E8257D-17D

Modification Available Performance Enhancement Service Note

E8257D Analog Signal Generator

Instrument failing self-test 704

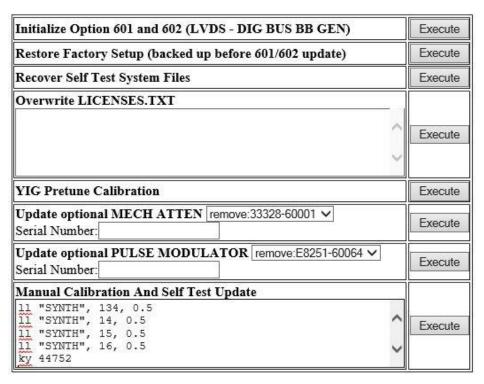
The self-test limits for A6 Frac-N to be updated to avoid possible faulty self-test failure 704. This applies for all instruments prefix <US4928/MY4928/SG4928 including units with Special Handling options HCC and HAR.

- 1. If you are experiencing self-test failure 704, verify the self-test limits by pressing: Utility > Instrument Information/Help Mode > Self-Test > View Test Info.
- 2. Using the RPG or the up and down arrow keys, scroll to self-test 704. Press: Run Highlighted Test.
- 3. When the self-test has completed, press: View Details. The lower limits for the following tests should be:

600-1000 MHz lower = 0.5 1-1.55 GHz lower = 0.5

1.55-2.4 GHz; lower = 0.5

2.4-3.2 GHz; lower = 0.5
